UN Regulation No. 149 (Road illumination devices)

Proposal for Supplement [12] to the 01 series of amendments to UN Regulation No. 45

Submitted by the Informal Working Group on Simplification of Lighting and Light-Signalling Regulations*

Figure
Diagram of Measuring Points on a Screen

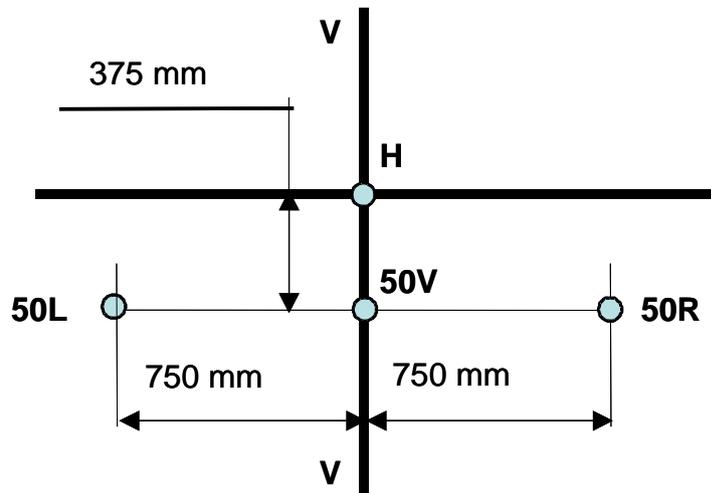
Paragraph 7.1., *amend to read:*

“7.1. The efficiency of the cleaner shall be tested in accordance with the requirements of Annex 4 to this Regulation. The cleaning efficiency at the points on the measuring screen which are specified below shall, after every cleaning period, amount to at least 70 per cent for the principal passing beam lamp and also 70 per cent for the optional driving lamp; in case of an AFS this provision applies to the photometric test procedures as defined in Annex 9 to Regulation No. 123 **or in Annex 4 to Regulation No. 149** from those lighting units in the neutral state indicated in paragraph 6.1.1. above. In the case of a headlamp (Regulation No. 98 or 112 **or classes A, B or D of Regulation No. 149**) providing bend lighting, the headlamp shall be set for the test in a straightforward direction.
